KINGSTON STEAM PLANT
SPILLWAY RELOCATION & DIKE "C" SEEPAGE REPAIRS

SCOPE OF WORK

KINGSTON DIKE "C"

COMMENTS ON PROPOSED FIX

A-A

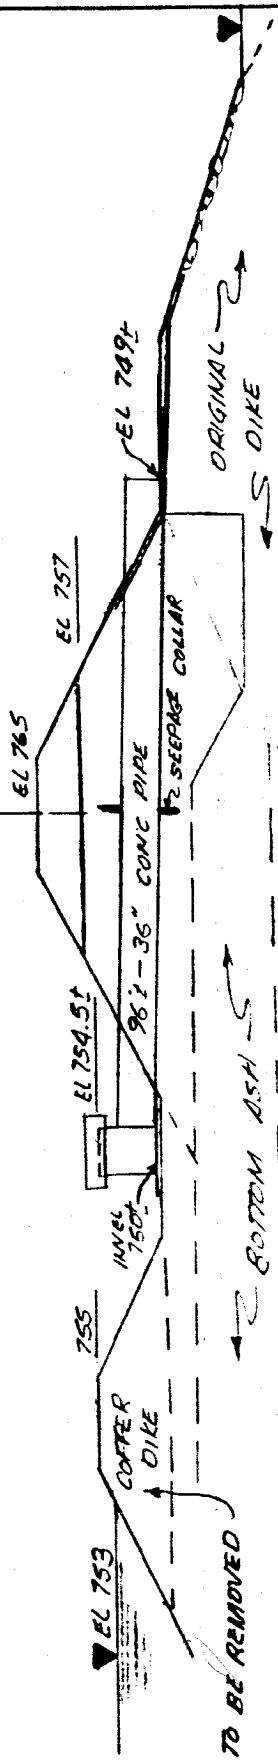
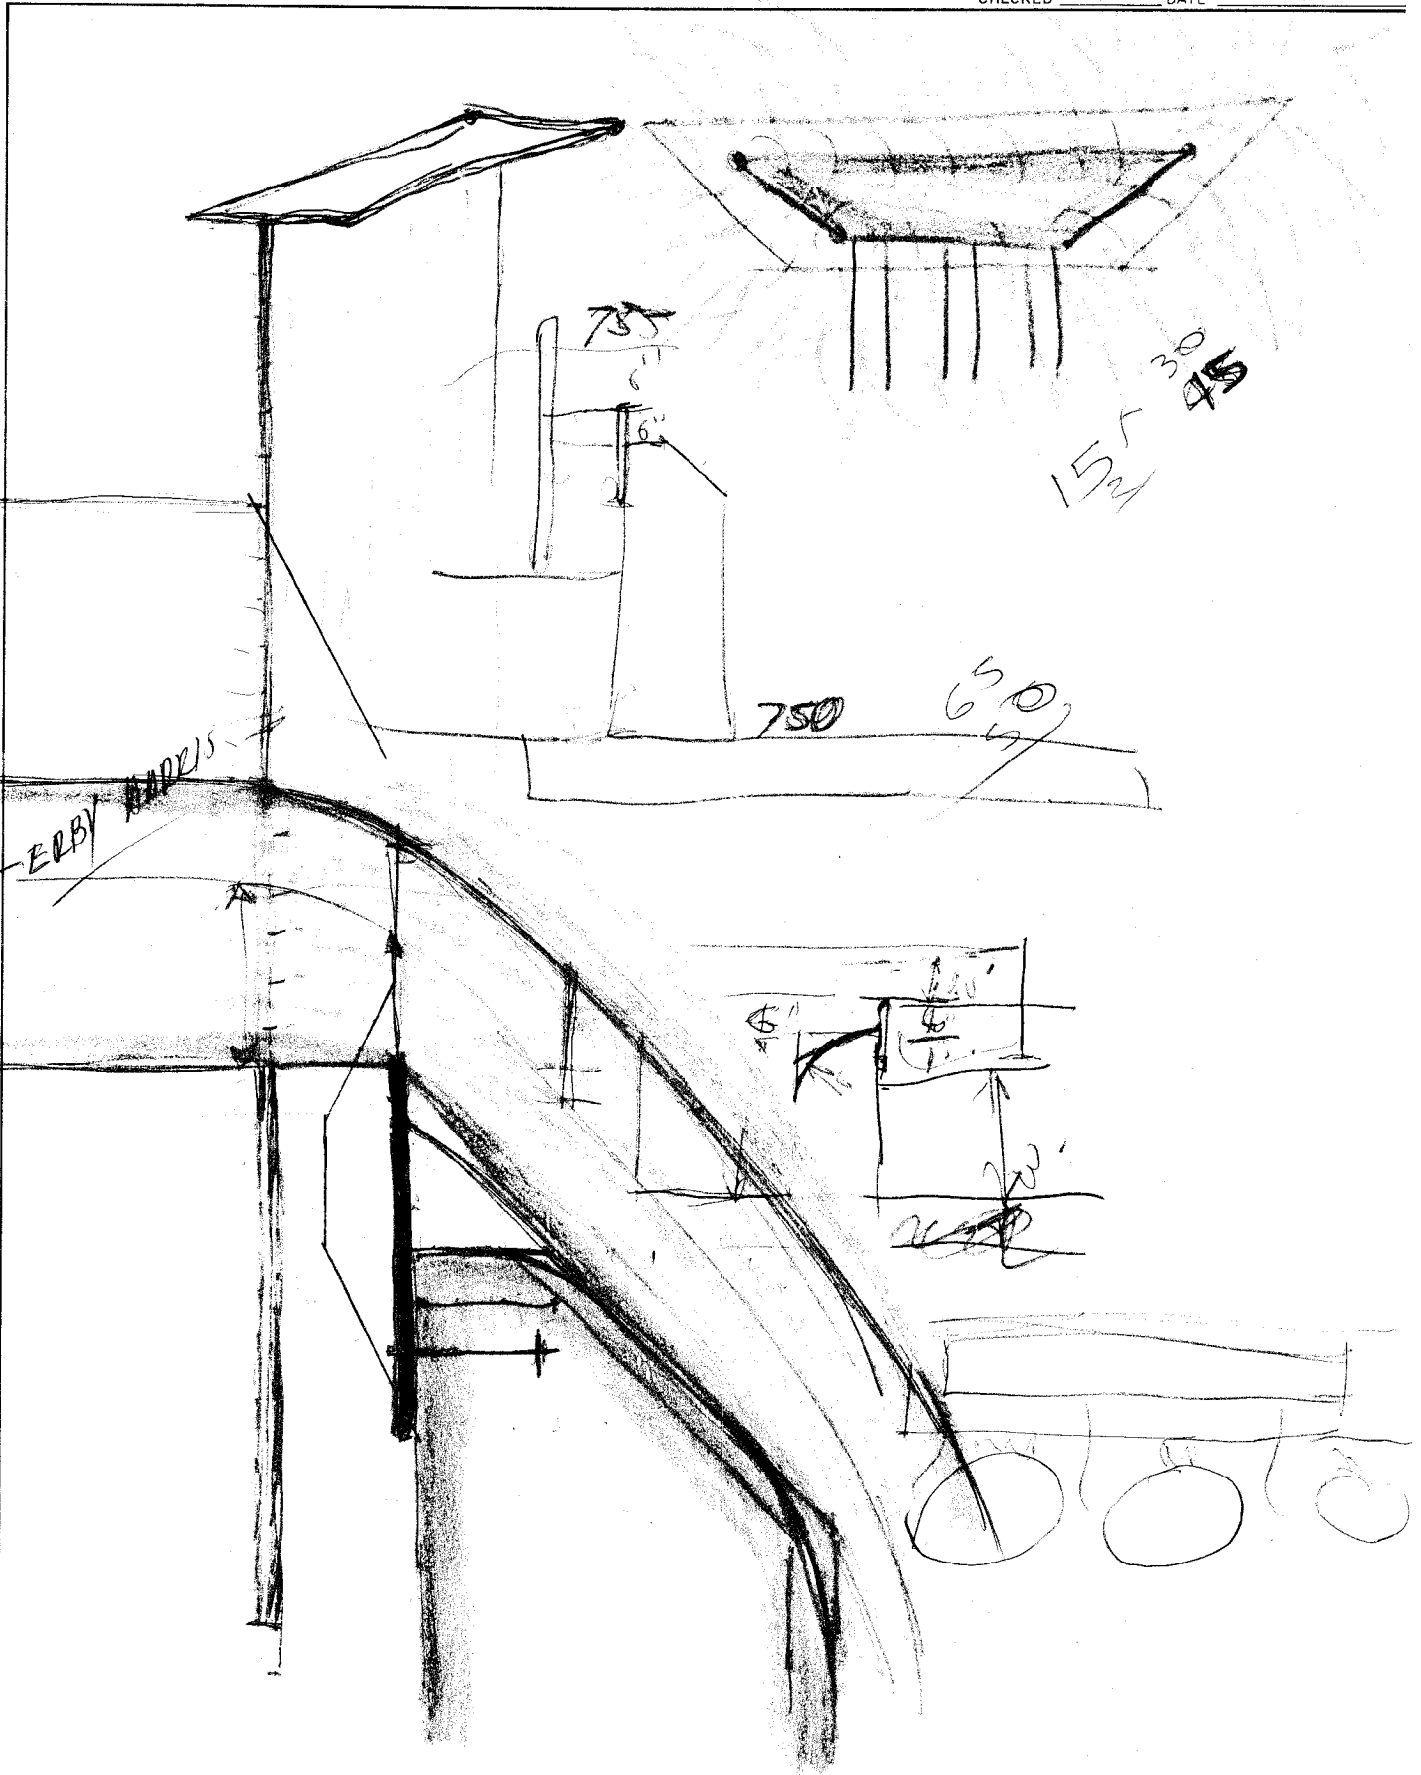
*we are going to need
 something to confine
 the water. (wall?)
 (with dike, riprap?)*

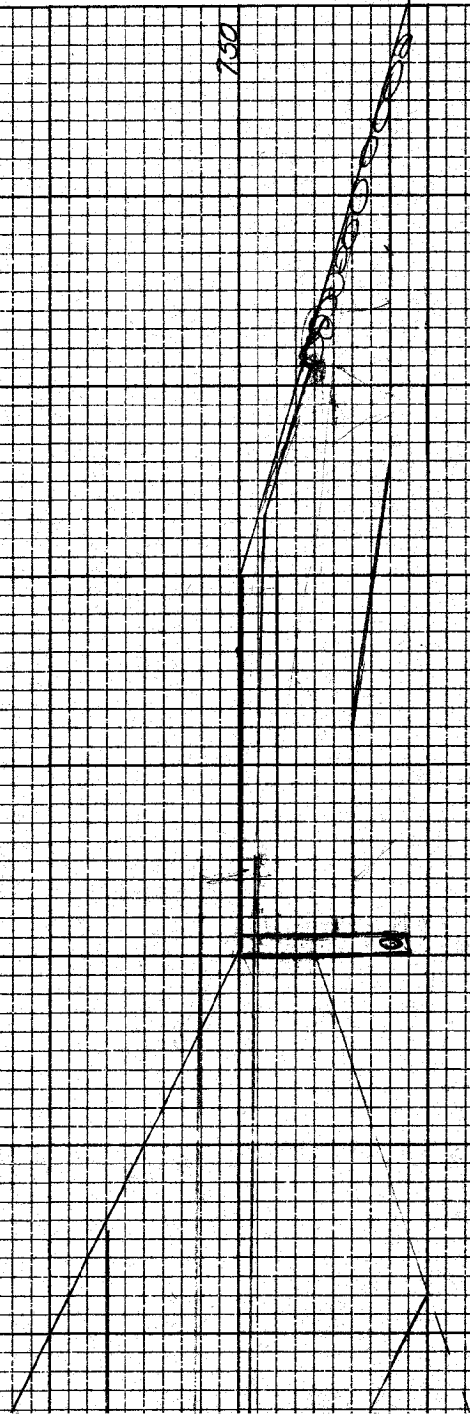
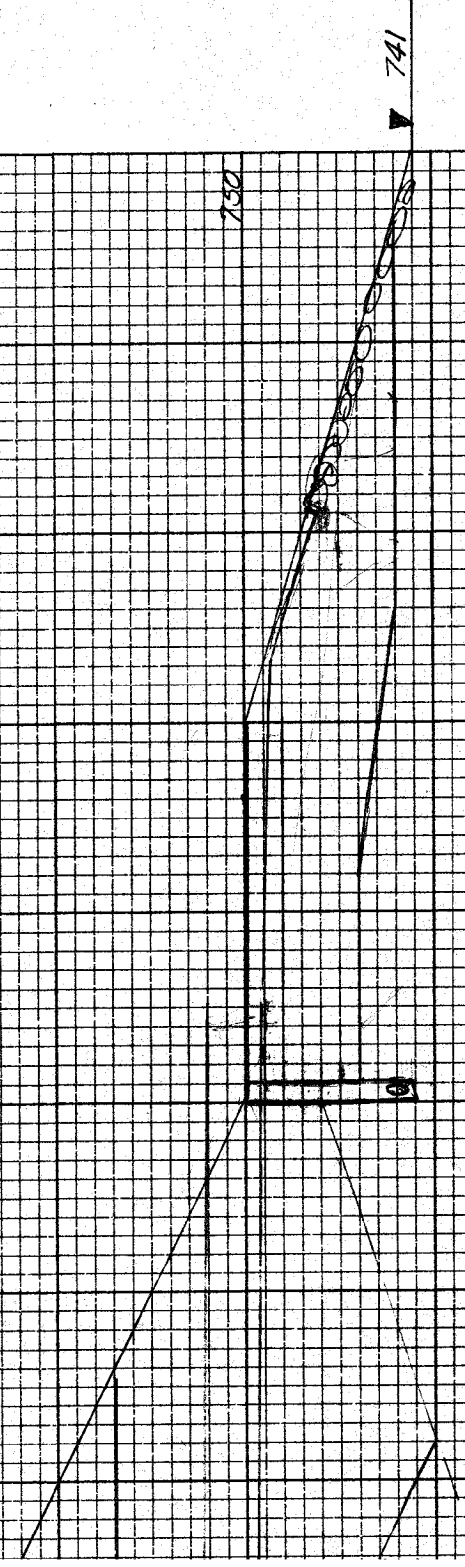
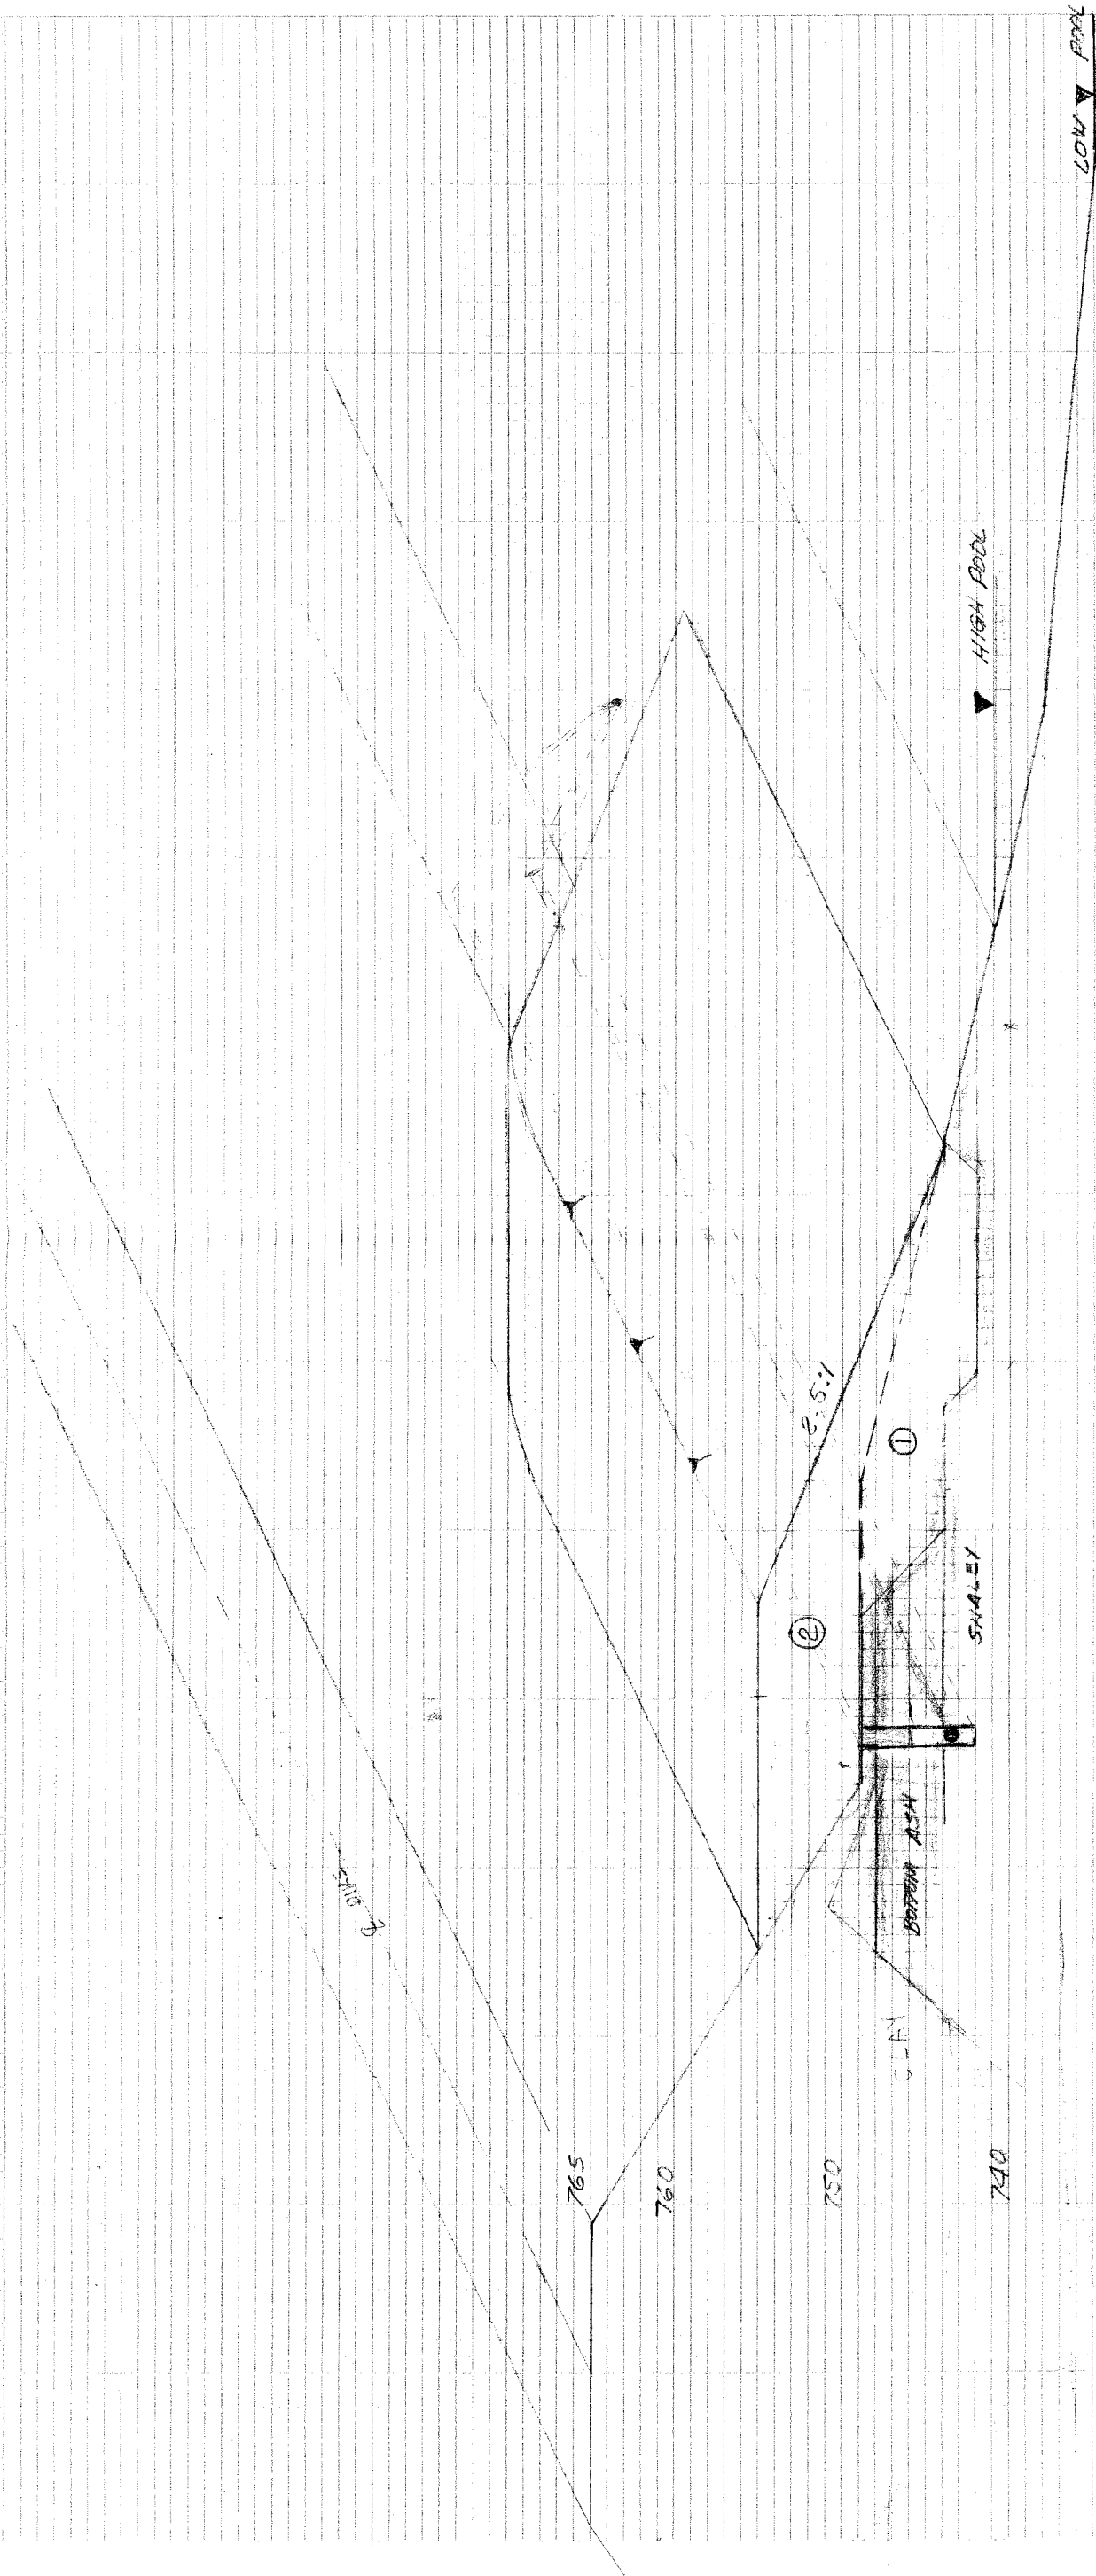
①. MAKE SURE THE TRENCH FOR THE 6" ϕ PERF. PIPE IS NOT LEFT OPEN FOR MORE THAN $\frac{1}{2}$ HOUR. THE MOVEMENT OF THE WATER MAY CAUSE A COLLAPSE AND UNKNOWN STABILITY.

②. AT STAGE ④ OF THE FIX, THE COMPACTION OF THE SOIL SHOULD BE BY SOIL RAMMER OR BACKFILL TAMPER NOT BY BACKHOE.

We agree in principle with your Concept. Pls let us review your final plans + notes. cmt

SUBJECT ATTACHMENT C

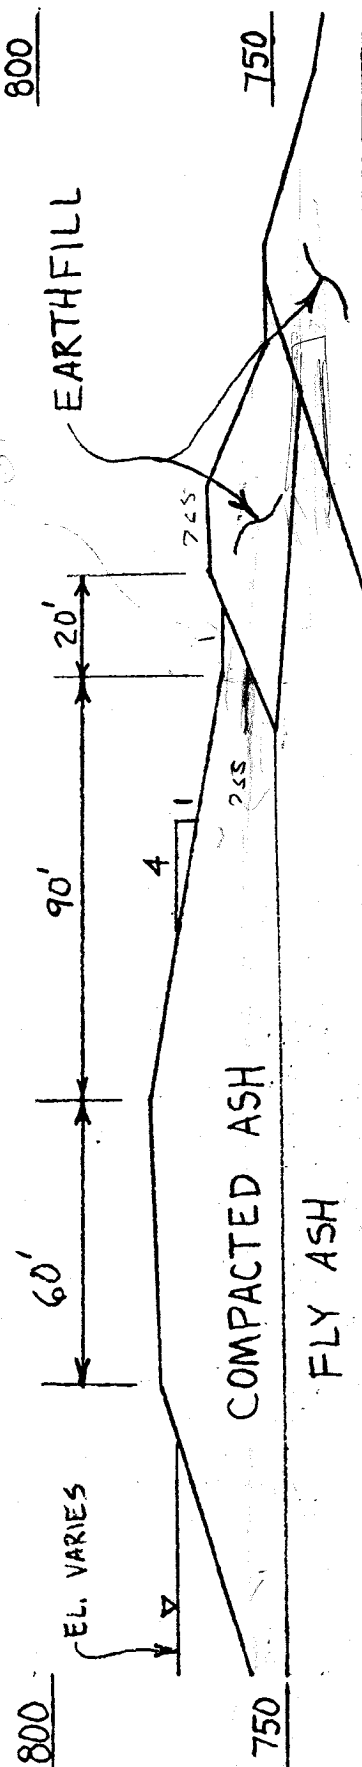
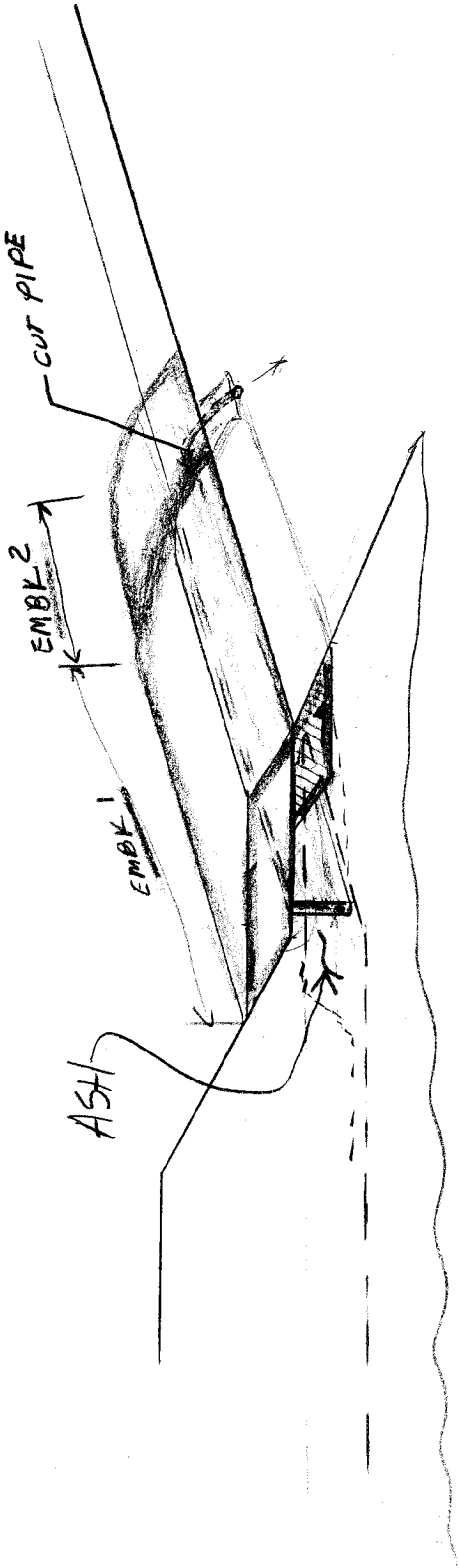
beginning @ what elevation?
